DUPLEX PUMP
CONTROL PANEL
WEST KENTUCKY

AS BUILTS

CP-2206

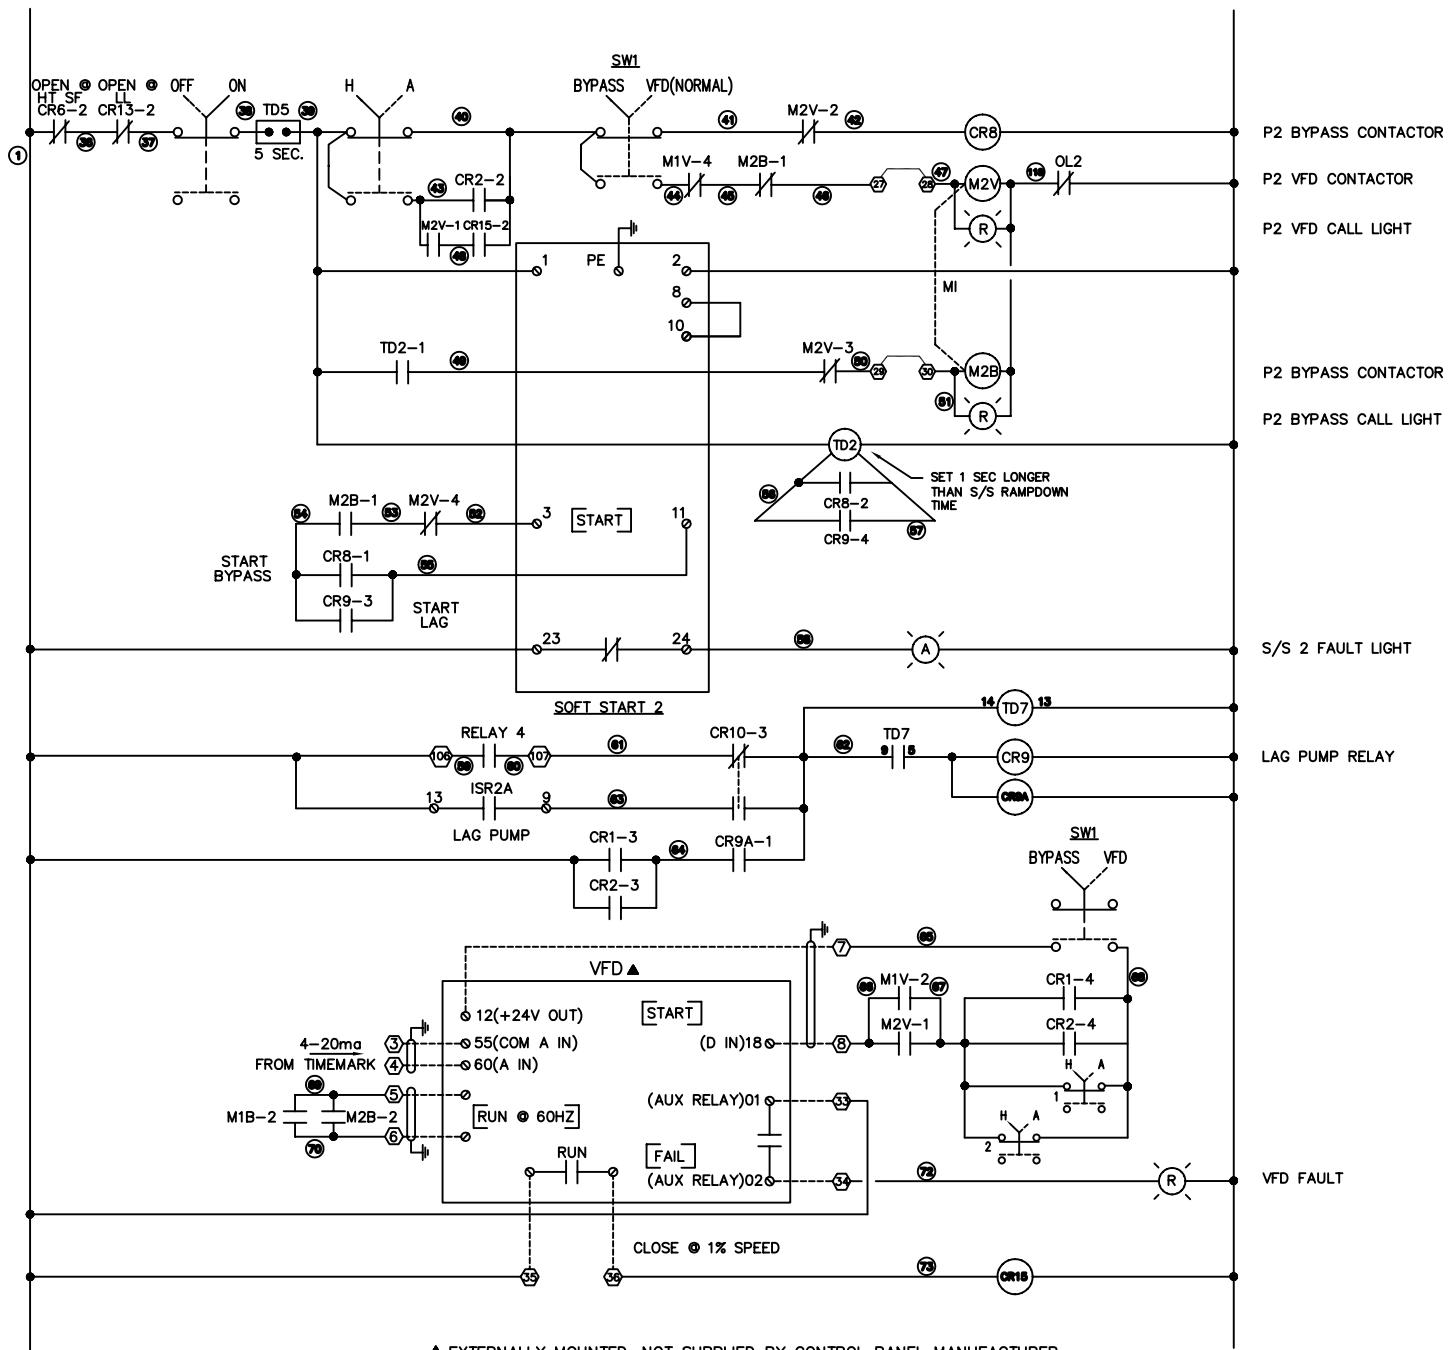
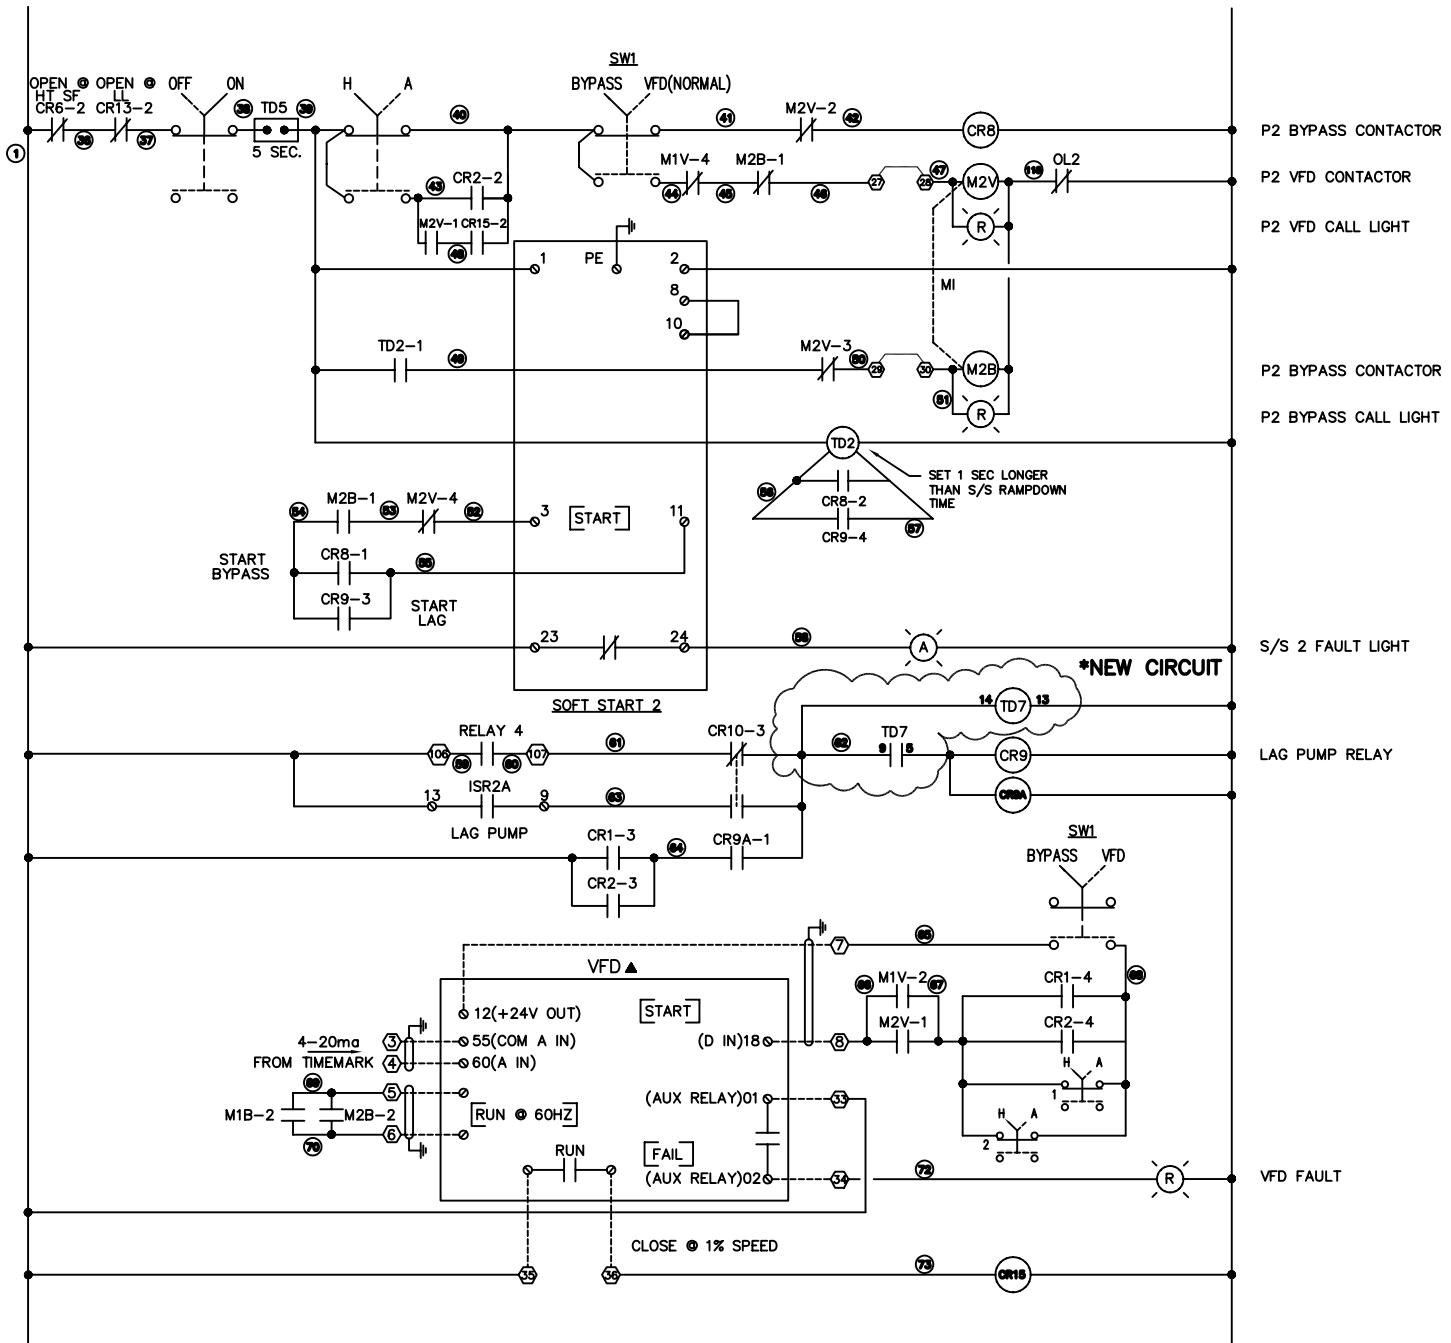
* REMOVE WIRE #62 FROM CR9 & 9A, MOVE TO TD7 # 9, 14
RUN NEW WIRE FROM TD7 # 5 TO CR9, 9A
RUN NEW WIRE FROM CR9 NEUTRAL TO TD7 # 13
